LARAMIE COUNTY PLANNING & DEVELOPMENT DEPARTMENT

TITLE: PUBLIC HEARING regarding a Vacation of Polk Addition, 2nd Filing, Tract 1, and application for a Subdivision Permit and Plat for Polk Addition, 3rd Filing, Laramie County, WY.

RE: RESPONSE TO PERMIT NUMBER: PZ-25-00058 SITE ADDRESS: 5320 E PERSHING BLVD

ADMINISTRATIVE PLAT
FOR
POLK ADDITION, 3RD FILING
BEING A REPLAT OF A TRACT 1 POLK ADDITION, 2ND FILING
LOCATED IN A PORTION OF SECTION 26 TOWNSHIP 14 NORTH,
RANGE 66 WEST OF THE 6TH PRINCIPAL MERIDIAN
COUNTY OF LARAMIE, STATE OF WYOMING
PREPARED SEPTEMBER 2025

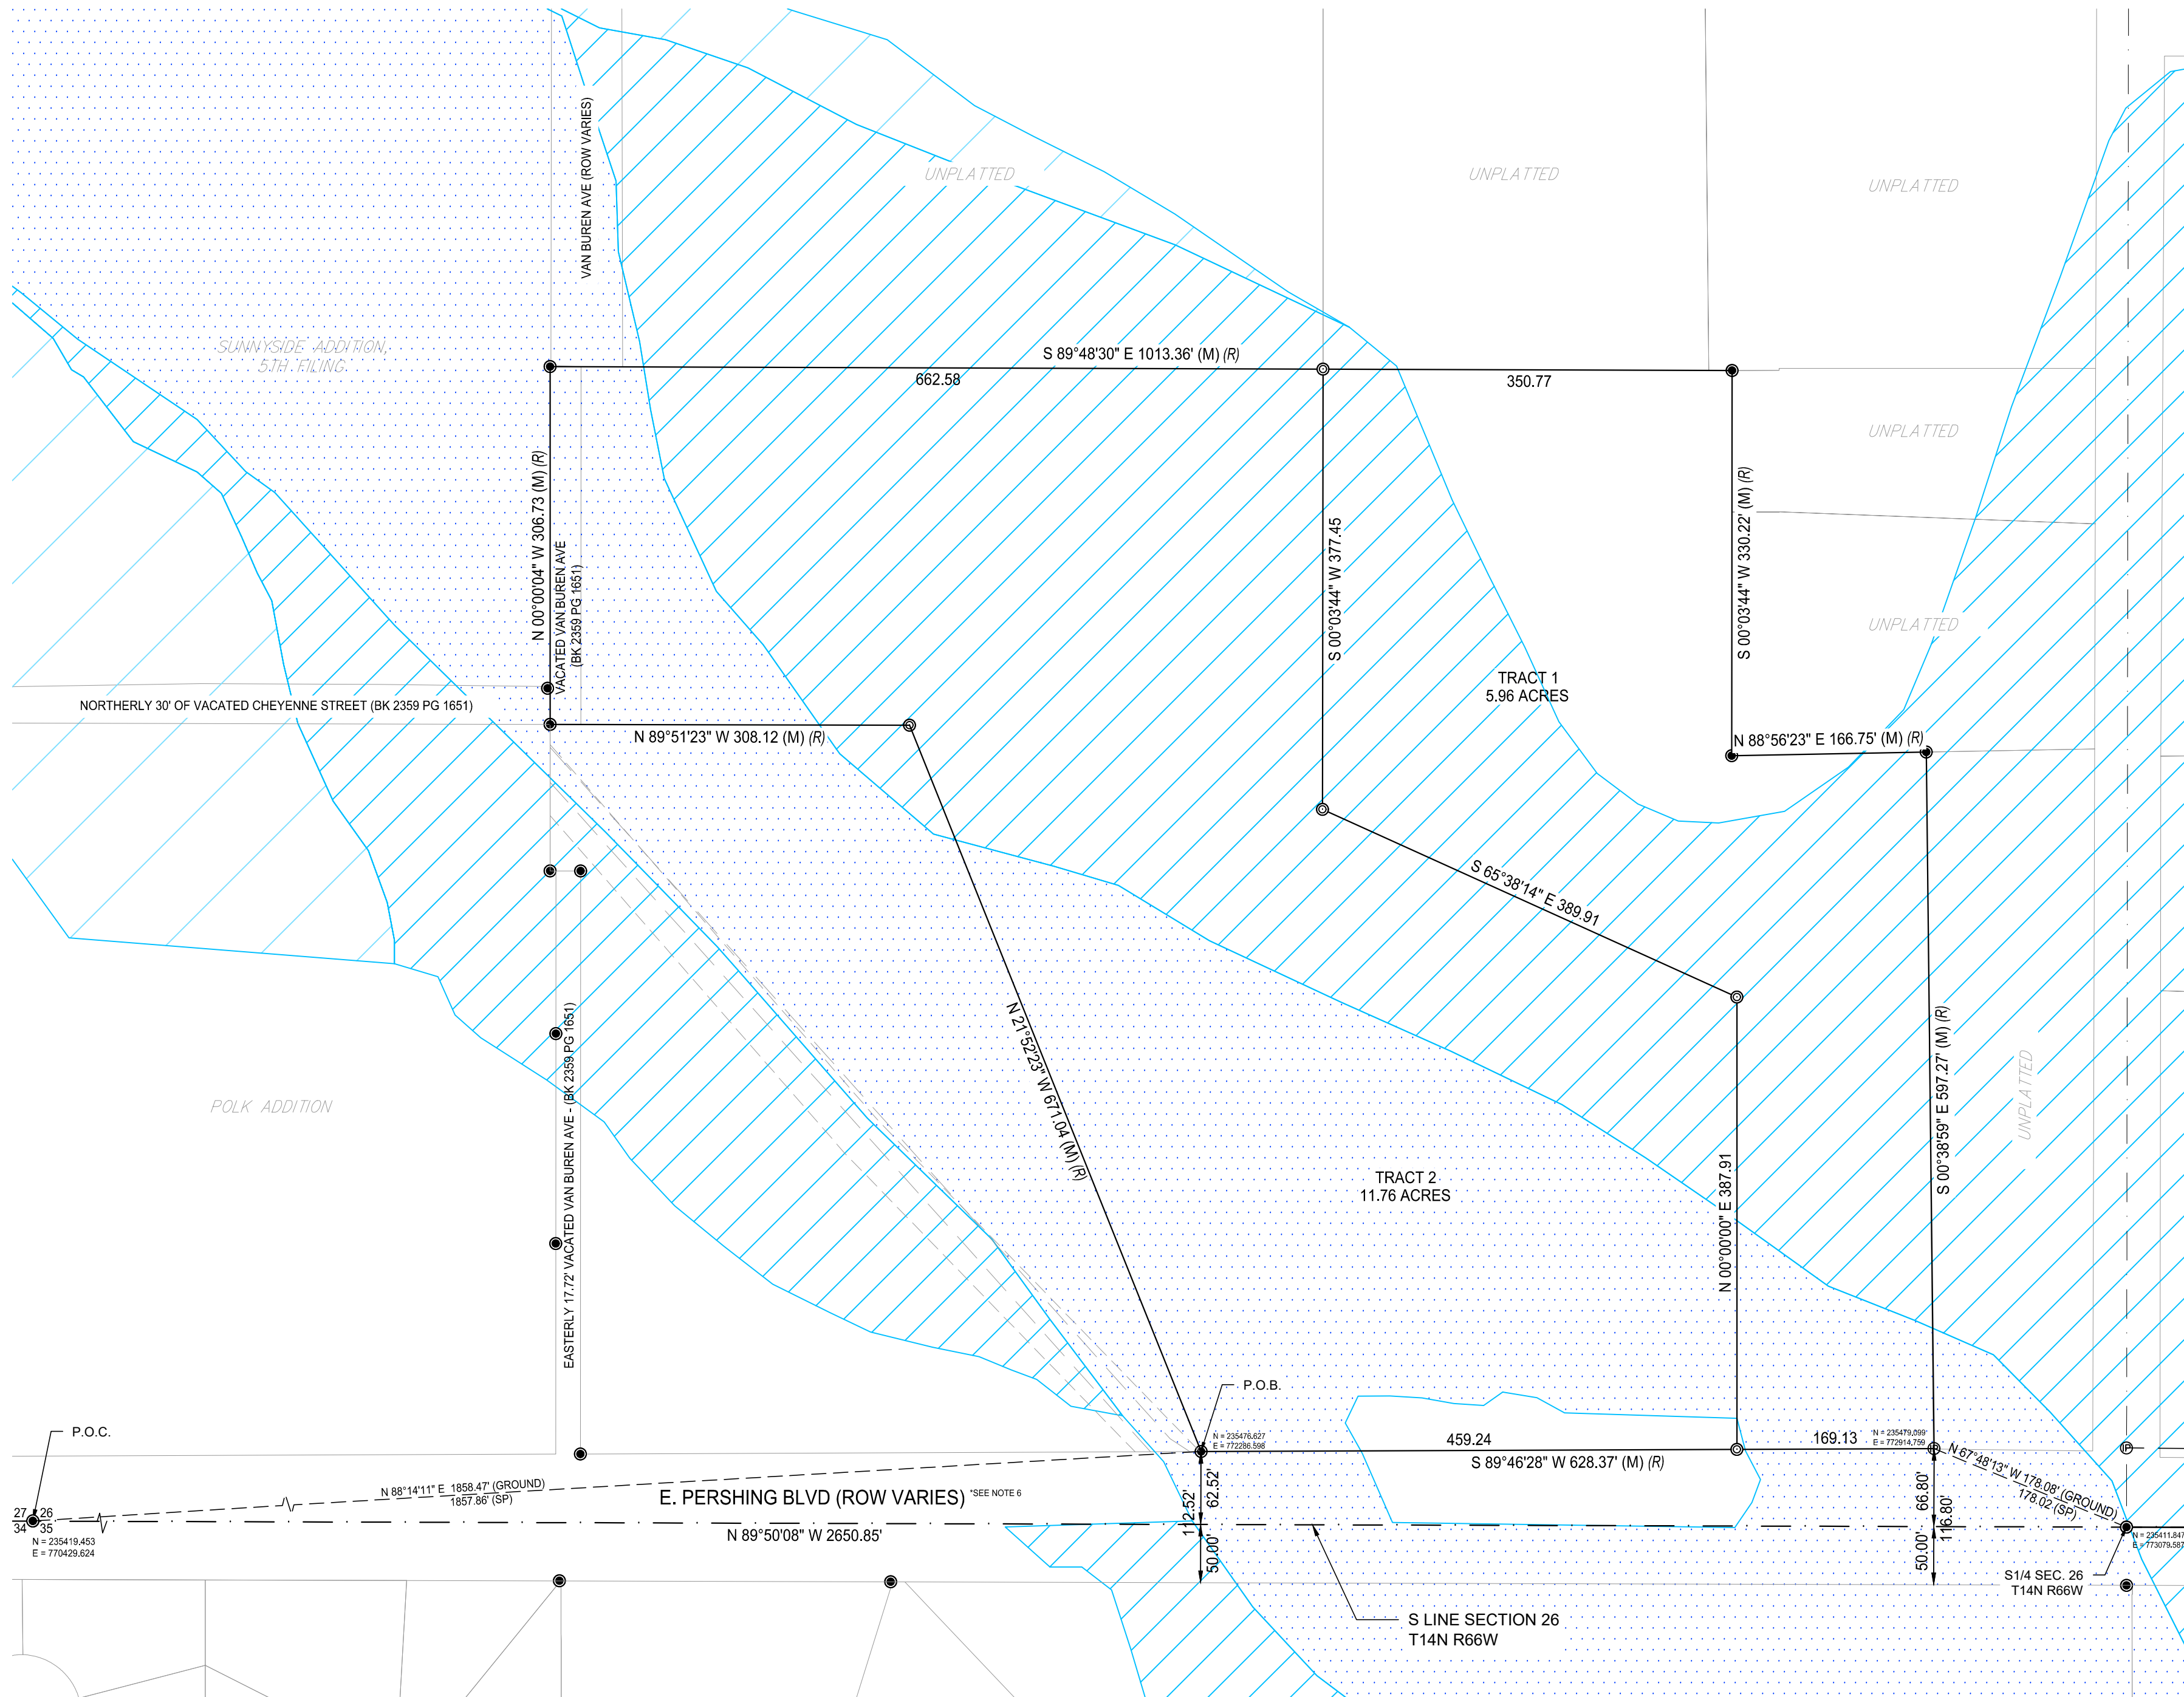
1. Until the floodplain mapping is properly changed through FEMA, no access can be constructed/built for Tract 1 off East Pershing Blvd since it is within the floodway. No construction can take place within the floodway area shown on the plat until or unless the FEMA maps are modified. Until then, how will Tract 1 be accessed? This plat is creating a Tract that cannot be accessed until the floodplain is modified or access is obtained in another area that is not within the floodway. *Acknowledged and discussed with Laramie County Planning and Development Program Manager.*

2. The Title Block needs to include "Section 26" in the legal description/location. *The title block has been updated.*
3. I agree a detailed Drainage Study and Traffic Study is not warranted for this plat. One or both may be required if/when a site plan application is submitted. *Acknowledged.*

4. It is understood that the ROW varies for Van Buren Avenue. However, please indicate the width where it ties into the property/platted line for Tract 2. *Acknowledged.*
